MEMORANDUM

Location: O. S Grid Ref: 332 495 12 Sontley Road, Wrexham.

Development: Application for approval of details reserved by conditions imposed under planning permission P/2014/0236:

- Condition 15 - Submission of a scheme detailing construction of the highway and access.**

Detail A - No-Dig Construction Footway - Design Ref. FP2

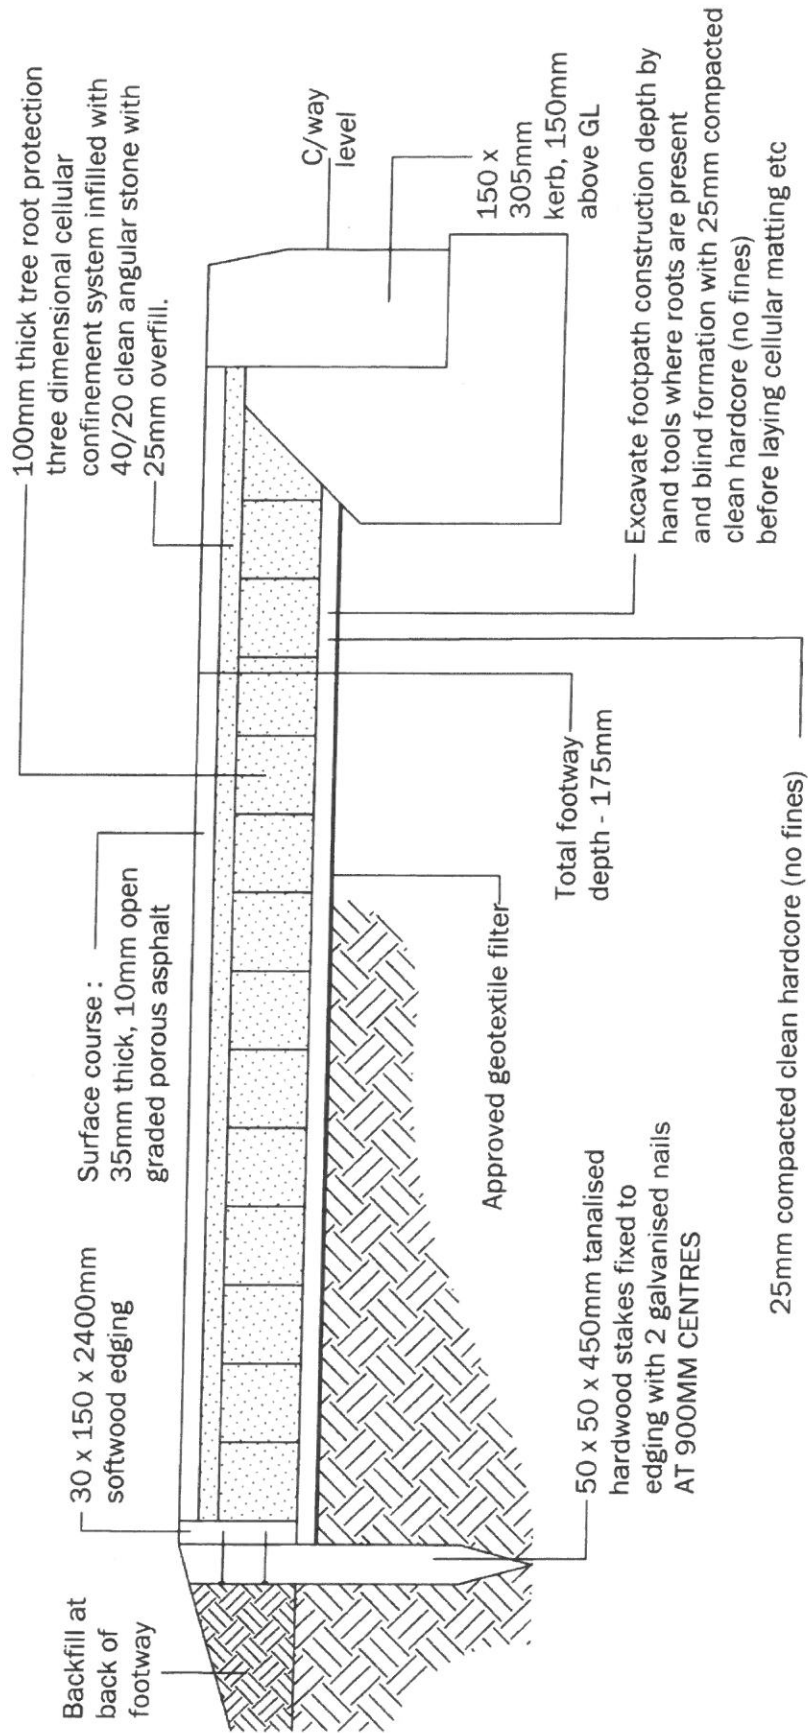
- I have forwarded a no-dig specification to our Tree Officer – Jon Brewin (see attached) for comment. I understand that he is ok in principle with the attached specification. However, he has raised the following queries:-
 - can you confirm that the kerb will sit on an existing base with no new or further excavations required
 - as the supporting 'backfill' will be around the stem base of the ash tree – how much backfill will be needed to retain the lateral pressures from the no-dig ? (too much backfill around the stem base and RPA of the tree may asphyxiate roots.)

- Having spoken with Jon Brewin, I understand that the proposed extent of no-dig construction footway needs to extend to the northern side of the proposed vehicular access to tie-in with the root protection zone. **Could you please extend the proposed no dig footway construction / red hatching on a revised layout plan**
- The proposed Aco drain appears to be connecting to the Highway Drainage System which is not acceptable. The proposed Aco drain will need to drain to a private soakaway within the curtilage of the development site. **Please amend this detail on a revised layout plan.**

- I have forwarded a no-dig specification to our Tree Officer – Jon Brewin (see attached) for comment. I understand that he is ok in principle with the attached specification. However, he has raised the following queries:-
 - can you confirm that the kerb will sit on an existing base with no new or further excavations required
 - as the supporting 'backfill' will be around the stem base of the ash tree – how much backfill will be needed to retain the lateral pressures from the no-dig ? (too much backfill around the stem base and RPA of the tree may asphyxiate roots.)

- Having spoken with Jon Brewin, I understand that the proposed extent of no-dig construction footway needs to extend to the northern side of the proposed vehicular access to tie-in with the root protection zone. **Could you please extend the proposed no dig footway construction / red hatching on a revised layout plan**
- The no dig footway construction surface course shall be 35mm thick, 10mm open graded porous asphalt. **Please include in notes.**
- The no dig footway detail indicates a wooden edging in lieu of a HB concrete kerb (adjoining carriageway) which is unacceptable. **Please amend this detail to include HB concrete kerbing (see attached detail).**
- Proposed bollard – please provide dimensions (see attached detail).
